**Subject:** **DRB CONDITIONS OF APPROVAL – FOLLOW UP  
MCLEOD MIXED USE PROJECT – FILE DRC07-00007**

### DESIGN RESPONSE CONFERENCE DESIGN REVIEW BOARD DECISION

**PROJECT NAME:** McLeod Mixed Use Project

**FILE NO.:** DRC07-00007

ARTIST'S RENDERING OF SOUTH COURTYARD ENTRY

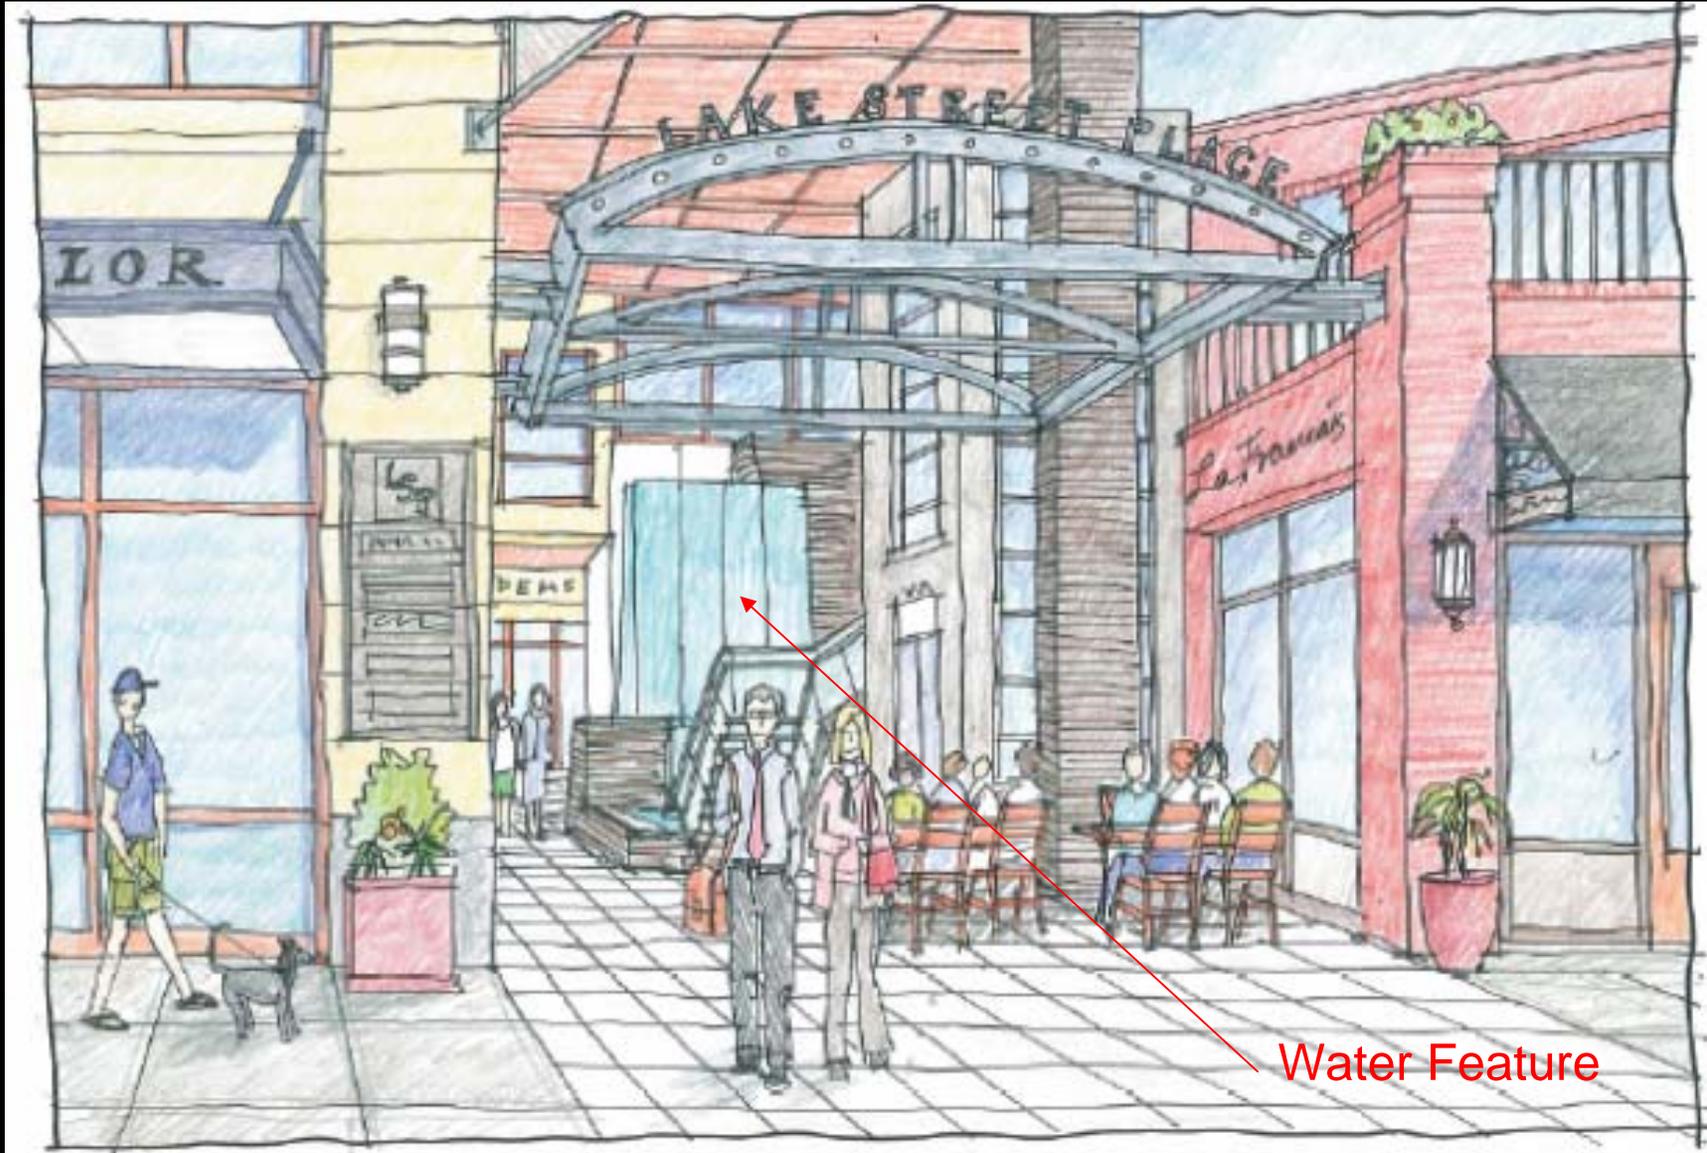
**CONDITION 13.** Details for the water feature to be located at the south entrance of the culinary court. The applicant should work with the Cultural Council in incorporating art into the design of the water feature.

- *The applicant has conducted an initial meeting with the Kirkland Cultural Council to determine opportunities for engaging local artists in the art projects including the design of the water feature. Details will be submitted with the Building Permit Re-Submittal.*
